To: Brandon Pike, Salem Planning  
From: Ben Schonberger, AICP  
Date: March 13, 2022  
Re: **Completeness Response Memo  
(case file 22 101695 00 RP)**

## **Salem Gateway Housing - Supplemental Adjustment Findings**

### **5205 Battle Creek Road SE, Salem case file 22 101695 00 RP**

To: Brandon Pike, Salem Planning  
From: Ben Schonberger, AICP  
Date: March 12, 2022  
Re: **Tree Variance, Lot 1**  
**(case file 22 101695 00 RP)**

Figure 1. Senior Building roof plan

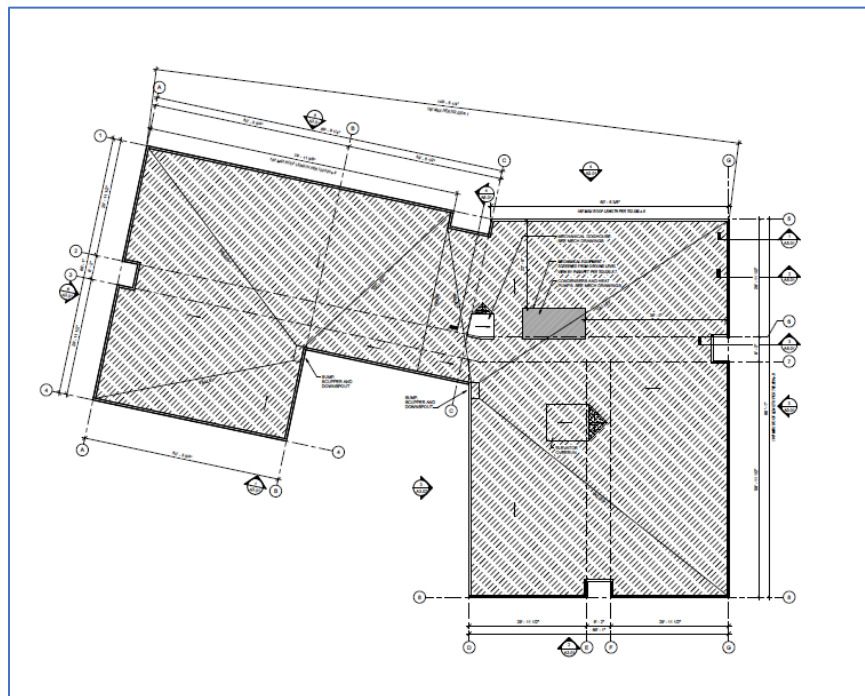
The first adjustment is from SRC 702.020(e)(1), which requires that no dimension of a building be greater than 150 feet. A horizontal measurement of the Senior Building from its southwest corner to its southeast corner, is 162.1 feet.

The building dimension differs from the standard by only 8 percent (*i.e.*, 162.1 feet vs. 150 feet), and is therefore subject to the Class 1 adjustment criteria.

**Figure 1. Tree Plan**

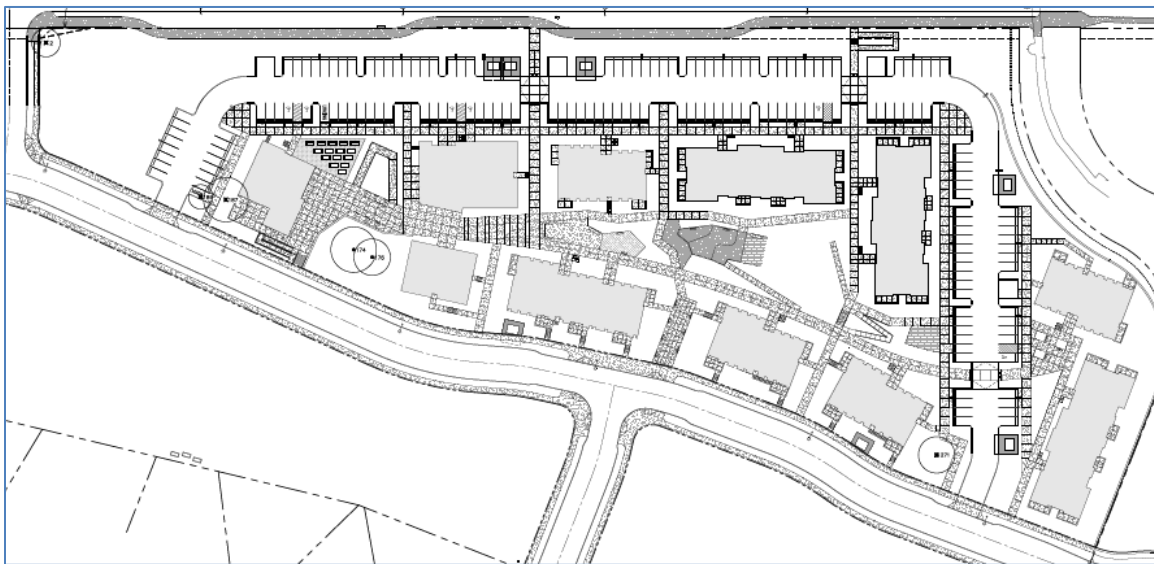
An attached plan shows the location of significant trees. Of those proposed for removal, Tree #2 is located at the intersection of Battle Creek Road and Foxhaven Drive, and Trees #187 and #189 are located on the north of the Community Building, close to Salal Street. The three trees to be saved are in a pocket between the Community Building and the Senior Building, and near the south driveway entrance to the parking area.

**Figure 2. Tree #2**

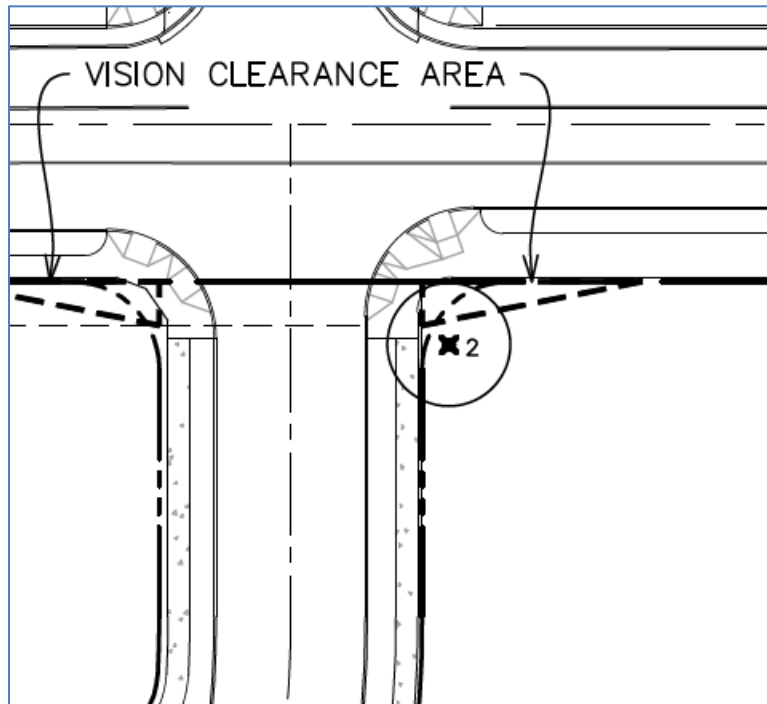
This tree, a 28-inch Oregon white oak, is located five feet from the property line at the corner of the Foxhaven and Battle Creek intersection.

This tree is only five feet from the edge of the Foxhaven Drive right of way. Likewise, it is immediately next to a “vision clearance area” for the Foxhaven/Battle Creek intersection, defined in SRC 805.005(a)(2). Although the trunk of the tree seems to lie just outside the defined vision clearance area, the branches and foliage of the tree are within that zone. Tree #1, a mature but smaller tree that does not meet definition of significant, is just east of Tree #2. The trunk of this tree is within the vision clearance triangle and is being removed partly for that reason. Obstructions to vision are prohibited within the vision clearance area, per SRC 805.010. No removal permit is required to maintain of a vision clearance area, per SRC 808.030(a)(2)(A). Being so close to a vision clearance area provides one justification for supporting the variance. Vehicles stopped at the intersection, exiting the new development, must have adequate sight distance to see oncoming northbound traffic. A 28-inch tree trunk interfering with the view in this direction creates a potential safety hazard. As noted, the subdivision layout and street alignments are set by the need to create a four-way intersection with Foxhaven and Battle Creek. Changing the location of the street to save this tree is not possible.

**Figure 3. Trees #187 and #189.**

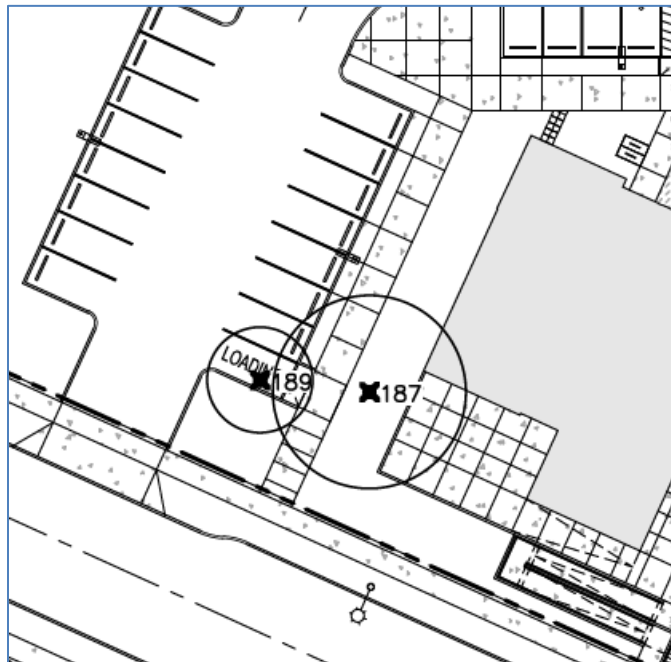
This tree, a 44-inch Oregon white oak, is located 30 feet from the edge of Salal Street in a cluster between the proposed Community Building and the driveway entrance to the parking area at the north side of the site. It is in a cluster with another significant tree, #189.

A physical conflict with the existing cluster of trees that includes Tree #187 is the need for vehicle access and parking. A root protection zone for Tree #187 would be 44 feet in diameter, and conflicts with the Community Building, a pedestrian path, and parking in the north parking area of the site. Access and parking are city requirements, and forgoing spaces is not an option. According to city code, 256 parking spaces would normally be required for the mix of housing units on the site (Table 806-1). The proposed site design includes only 164 parking spaces. This is 92 fewer spaces than the typical minimum. Reductions for low-income housing allow this amount of parking to meet city standards (See footnote 2 of Table 806-1.) After taking these reductions, the site layout has the absolute minimum allowed by the code. In other words, the applicant has limited site parking as much as possible to make room for higher-value uses — buildings, open space, plazas and pedestrian areas, and also some tree protection. Nevertheless, nearly 1.5 acres of paved vehicular and parking area is required by city code, even at a dramatically reduced level. Providing parking and vehicle area comes at the expense of other things, including trees.
